Access Compliance Report

Public Rights-of-Way

(Curb Ramps)

Intersection ID: 46821	Main Street: RED_PINE_CT	Cross Street: AZALEA_HILLS_DR	Location: E
ADA ID: 17EA1BAF33F2	Ramp Type: PerpDiag	Initial Pass/Fail: Fail	Overall Compliance: No
Severity Score: 10			
Codes/Mitigation Info/Possible Solution		Field Measurements/Component Compliance

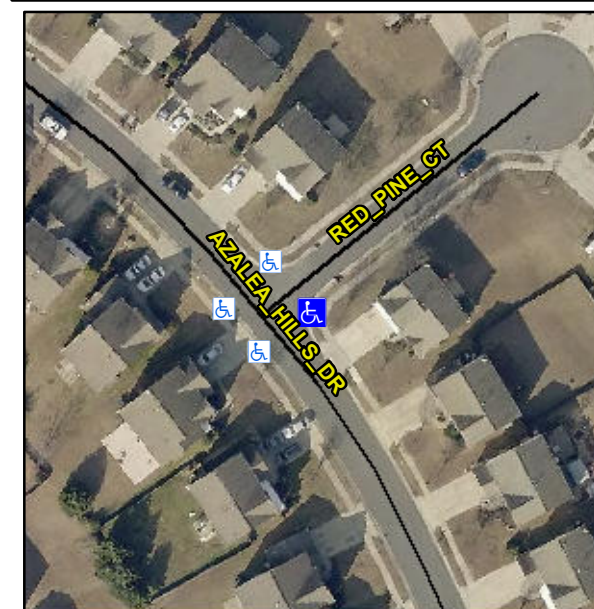
Not Found, R304.5.1, R304.5.3

Compliance	Description	Data	Compliance	Description	Data
N/A	Ramp Length (in)	47.5	Yes	Ramp Slope (%)	5.6
No	Ramp Width (in)	41.2	No	Ramp XSlope (%)	3.0
N/A	Flare Type LT	N/A	N/A	Flare Type RT	N/A
N/A	Flare Slope LT (%)	N/A	N/A	Flare Slope RT (%)	N/A
N/A	Flare Traversable LT?	N/A	N/A	Flare Traversable RT?	N/A
N/A	Landing Length (in)	N/A	N/A	DWS Provided?	N/A
N/A	Landing Width (in)	N/A	N/A	DWS Contrast?	N/A
N/A	Landing Slope (%)	N/A	N/A	DWS Length (in)	N/A
N/A	Landing X Slope (%)	N/A	N/A	DWS Full Width?	N/A
N/A	Landing Curb? (Y/N)	N/A	N/A	DWS Offset (in)	N/A
N/A	Shared Landing?	N/A			
N/A	Gutter Ponding?	N/A	N/A	Gutter Slope (%)	N/A
N/A	Gutter Lip Ht (in)	N/A	N/A	Gutter X Slope (%)	N/A
N/A	Painted X Walk1?	No	N/A	Painted X Walk2?	No
	X Walk 1 Direction	To NW		X Walk 2 Direction	To SW
N/A	X Walk 1 Width (in)	N/A	N/A	X Walk 2 Width (in)	N/A
	X Walk 1 Slope (%)	0.2		X Walk 2 Slope (%)	2.7
	X Walk 1 X Slope (%)	3.7		X Walk 2 X Slope (%)	3.0

N/A	Ramp inside XWalk1?	N/A	N/A	Ramp inside XWalk2?	N/A
	Road Slope (%)	3.0	N/A	Clear Space?	N/A
	Road X Slope (%)	0.7	N/A	Clear Space to XWalk (in)	N/A
N/A	Any Obstructions?	N/A	N/A	Storm Grate/Utility Hazard?	N/A
	Obstruction Type			Storm Grate/Utility Type	
		N/A			N/A
		Yes		Surface Condition? (G/P)	Good

Remove & Replace Curb Ramp With Two New Directional Ramps or Equivalent.
